ADDENDUM B, 10/20/2025

RE: **MURRIETA VALLEY UNIFIED SCHOOL DISTRICT**
POOL MODERNIZATION
DSA File Number: 33-32
DSA Application Number: 04-123133
Studio W Project Number: 23071

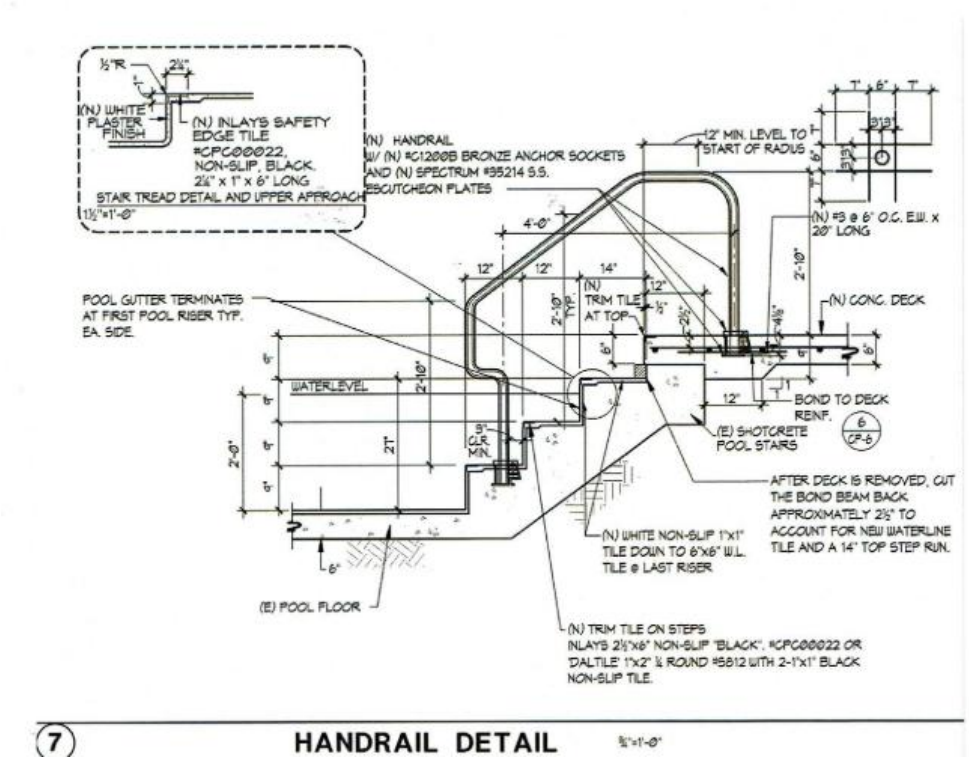
4. Please clarify assumed thickness of the existing pool deck.
   Response by ADG: Contractor to assume the existing pool deck conditions to be a minimum 6-inch thick deck, 14-inches at deck drain, and approximately 9-inches at the top of the pool wall.

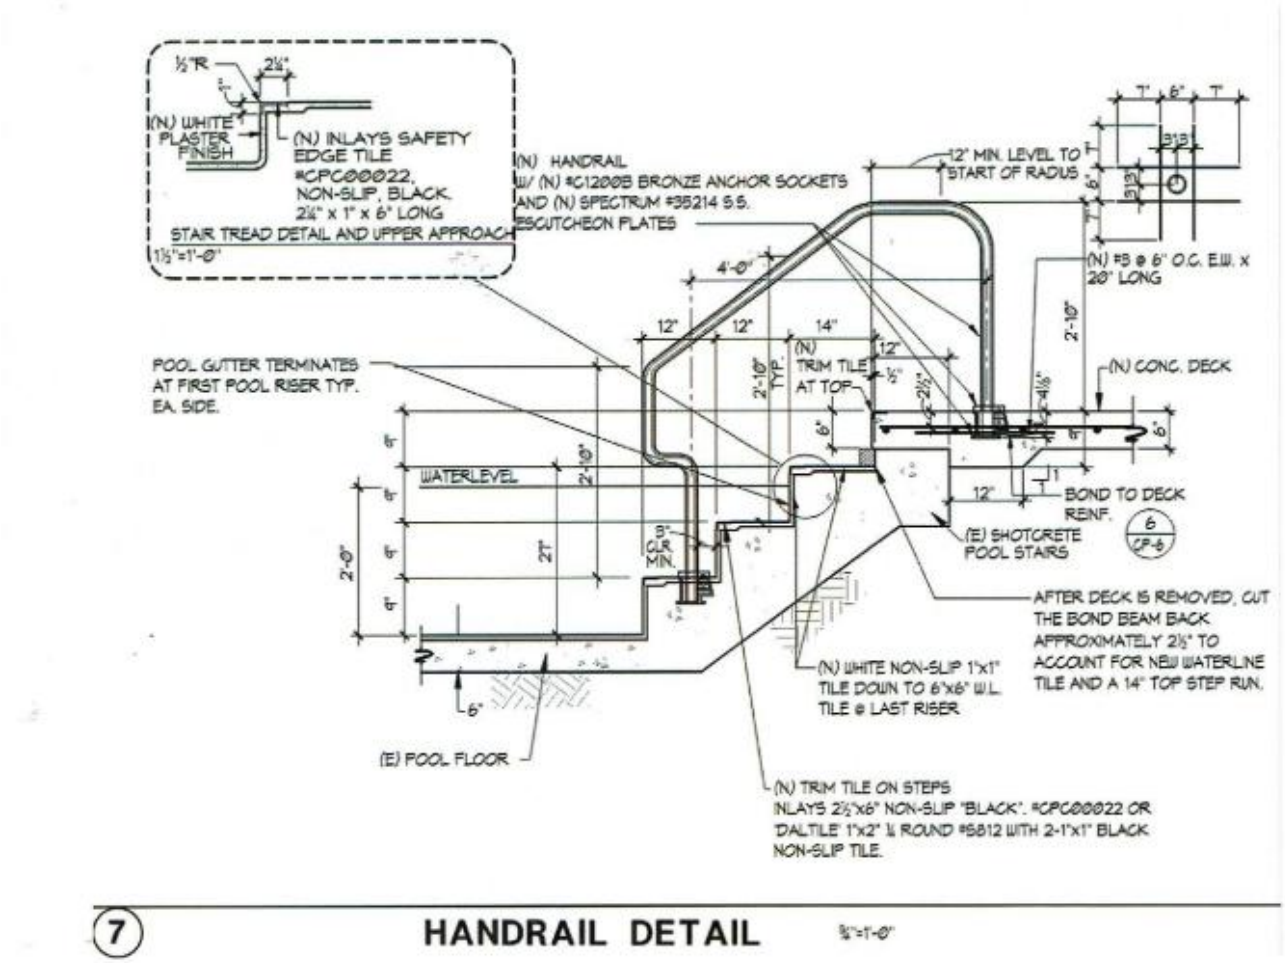
9. Plan sheet DP-1 Note 22 states to extend top stair tread 2-inches. Plan sheet CP-4 detail 7 does not show this extension meeting 14-inch width. Please provide revised plan details.
   Response by ADG: See revised detail:

10. Plan sheet CP4 detail 7 notes new handrail but detail has incorrect dimensions for new steps. Please provide revised details to obtain correct handrail dimensions if custom shape.
    Response by ADG: See revised detail:
